SUBJECT: PLANS AND PROPOSAL ADDENDUMS
PROJECT: STP 2023 (675)MM CONTROL: 1433-02-044
COUNTY: COMAL
LETTING: 05/04/2023
REFERENCE NO: 0419

PROPOSAL ADDENDUMS

DESCRIPTION OF ABOVE CHANGES
(INCLUDING PLANS SHEET CHANGES)

LEGEND

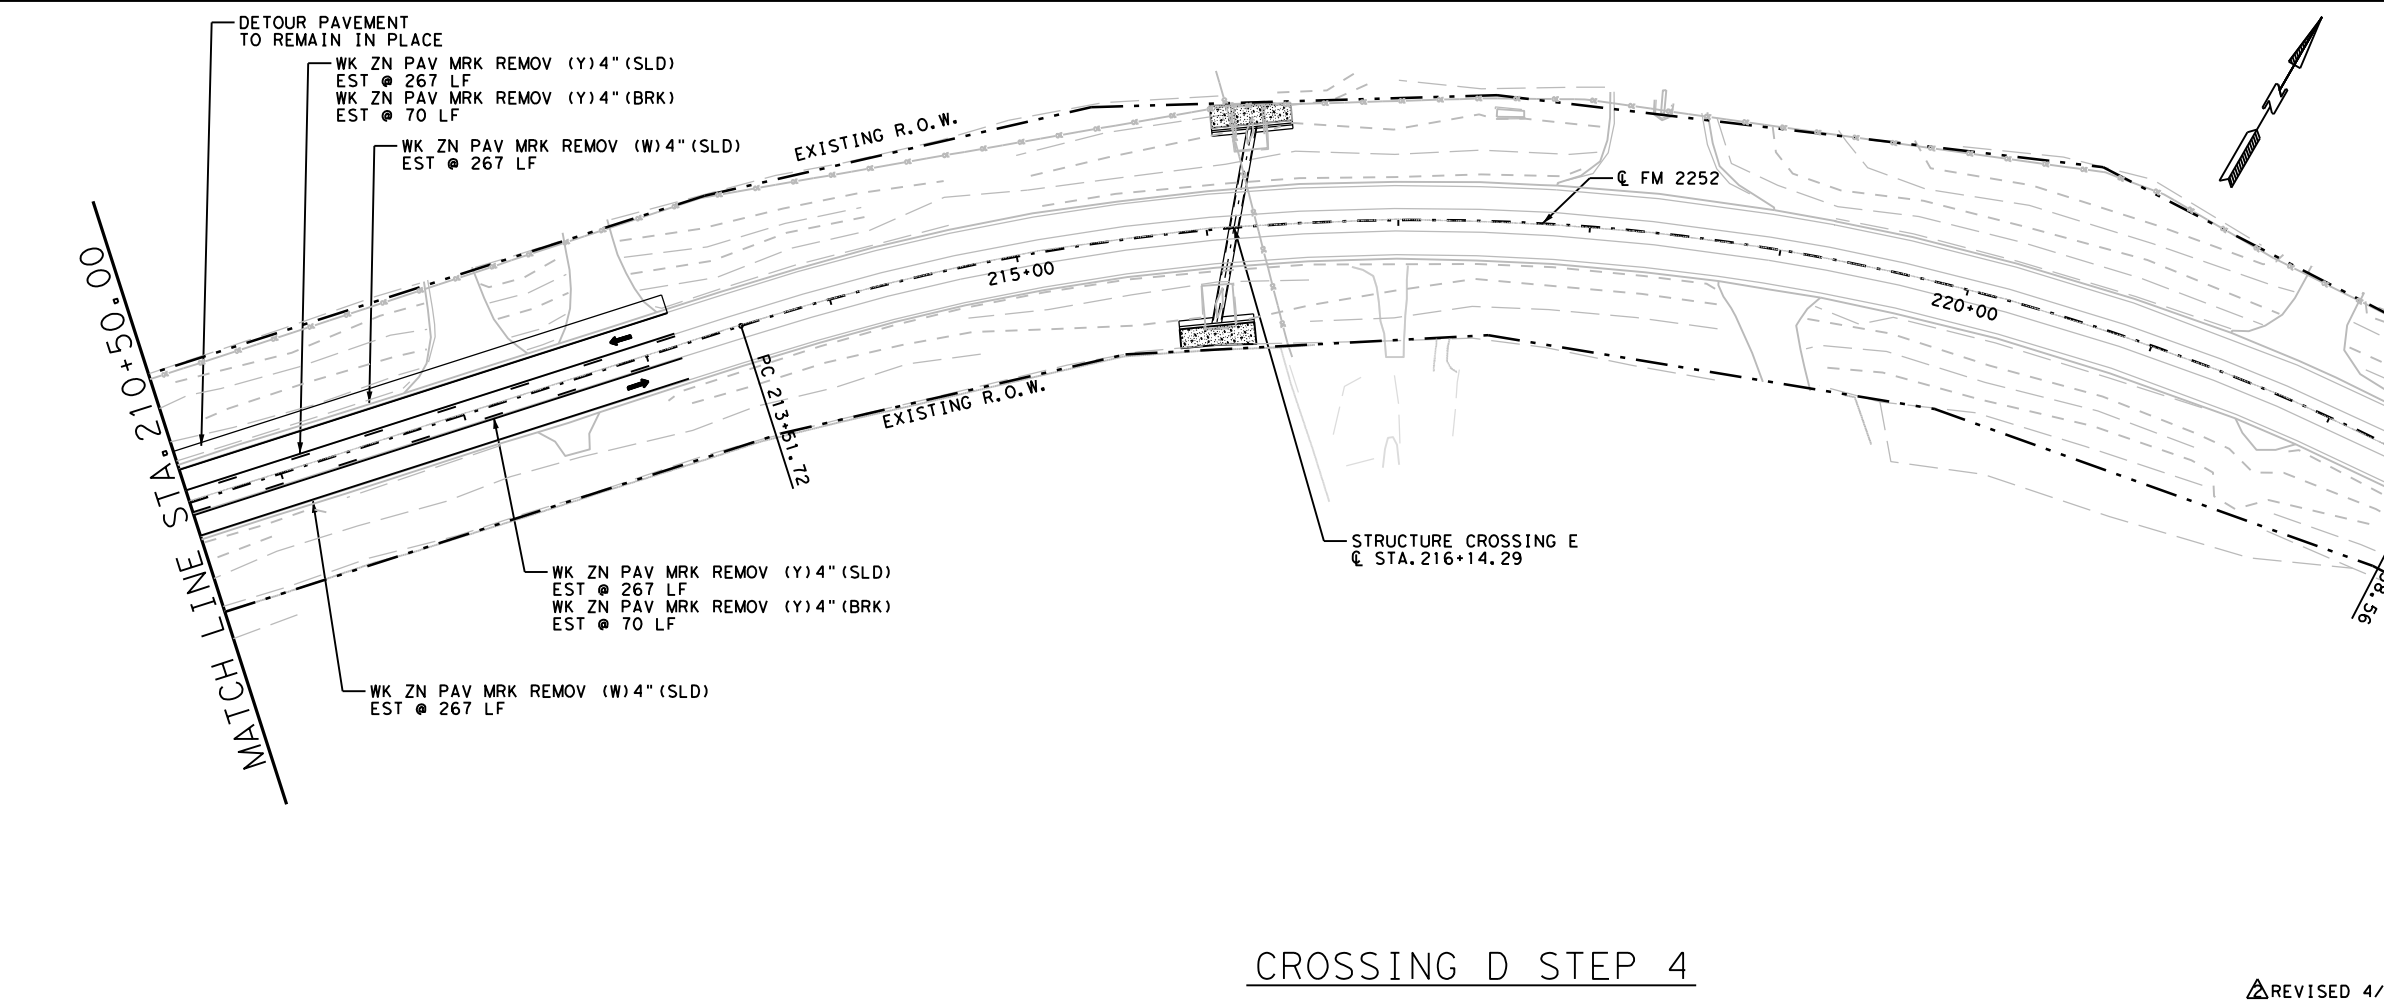
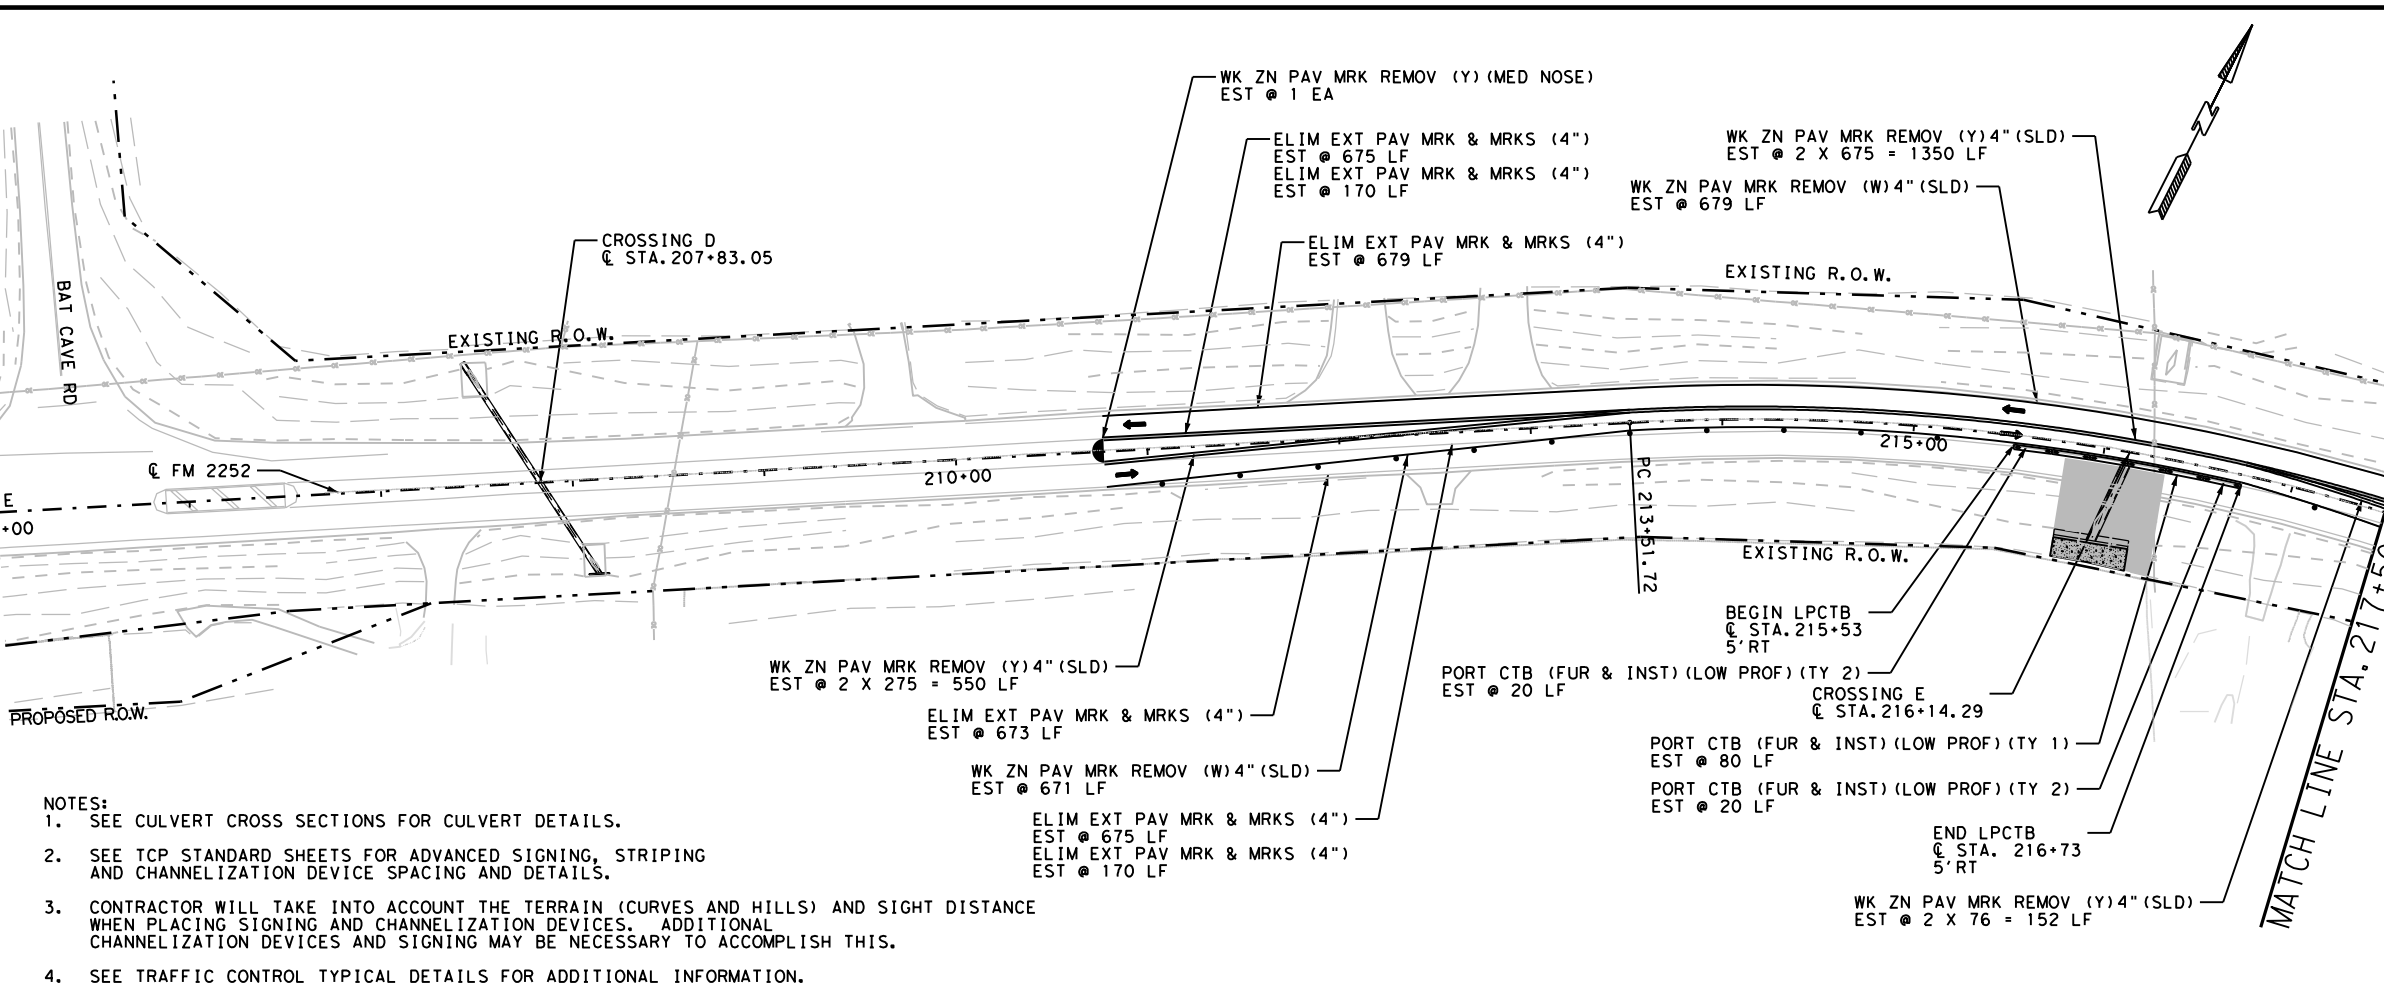
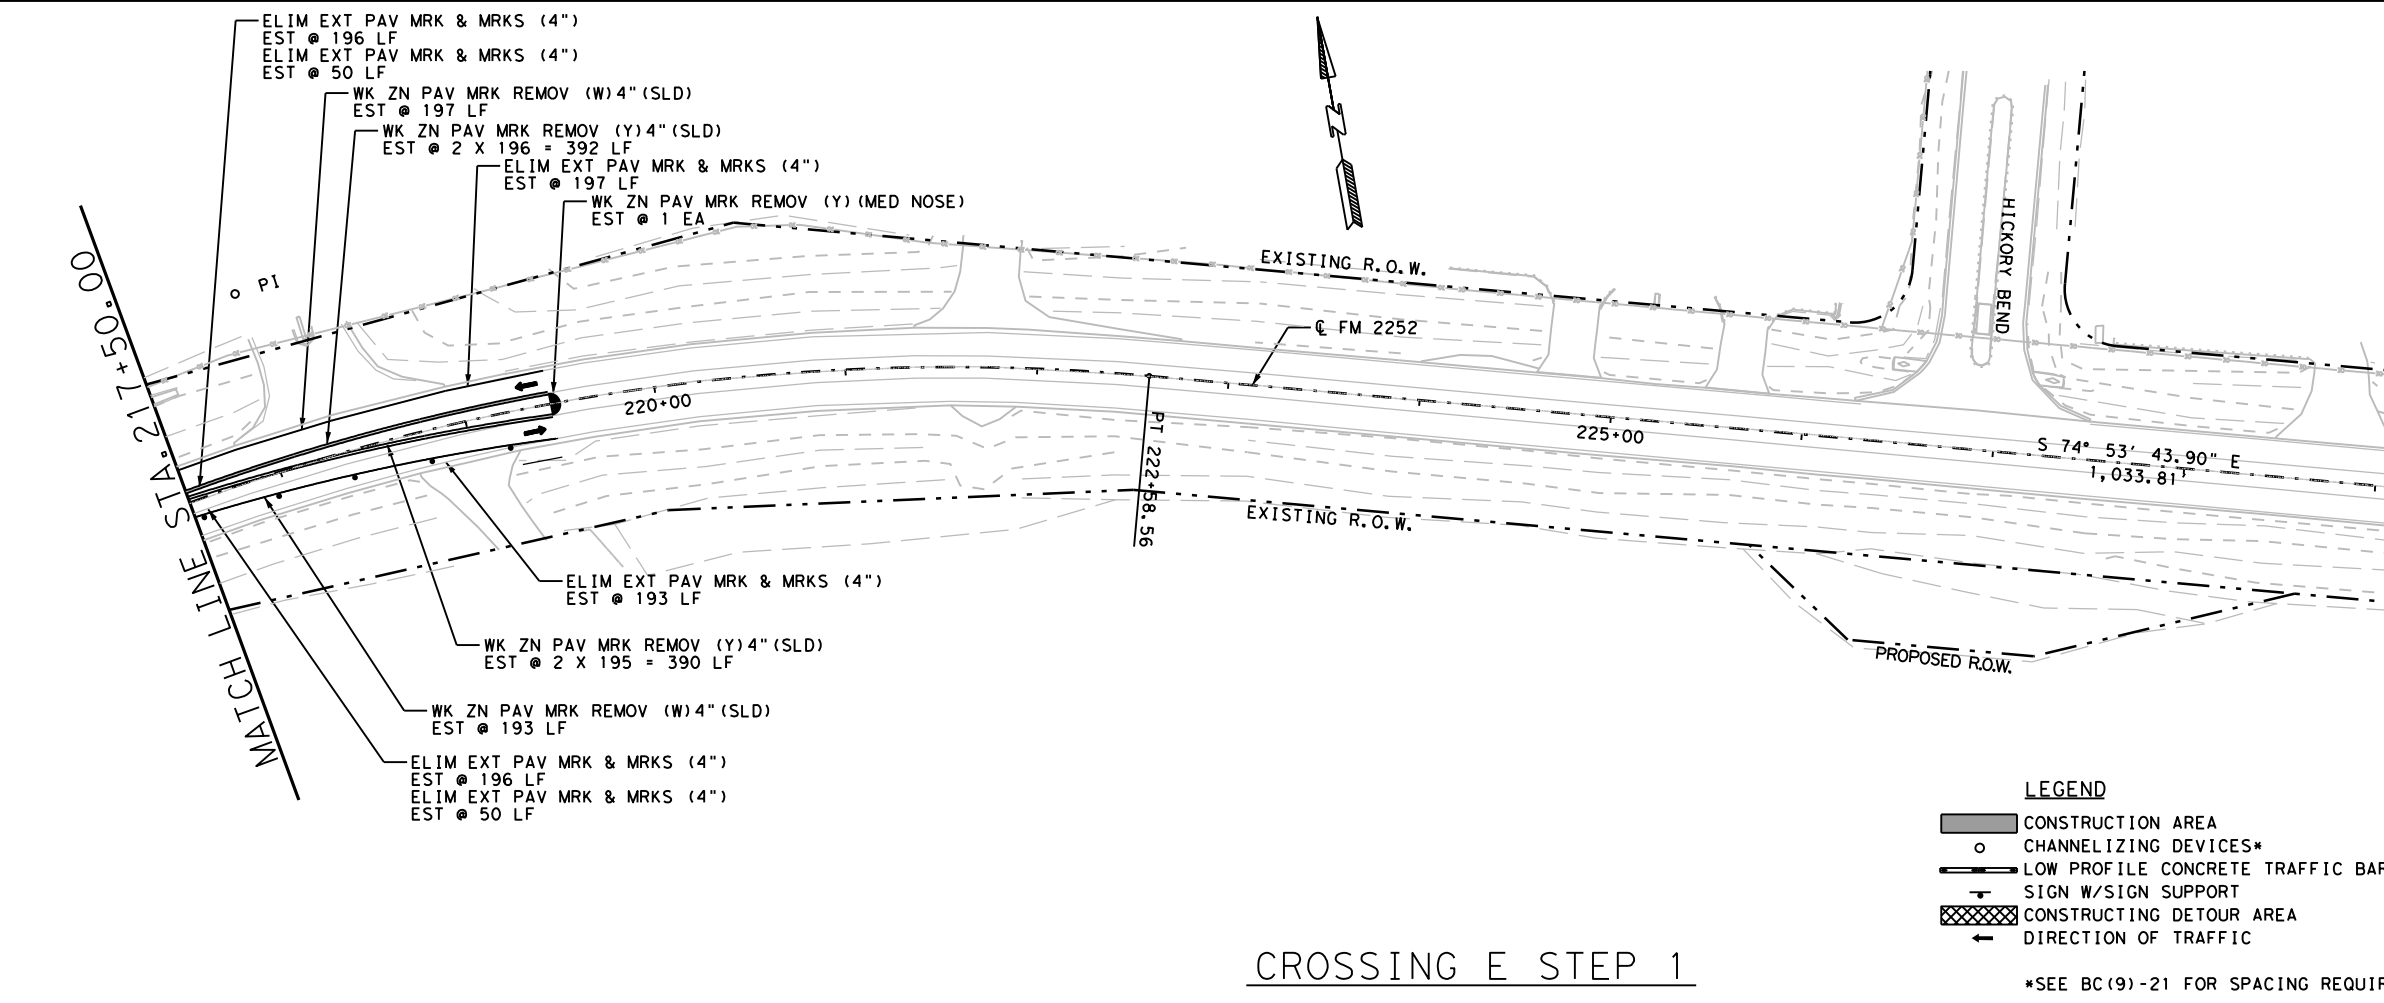
SHEETS 275-278, 280-283, 285-288 AND 290-293: ADDED ITEM NO. 403-6001
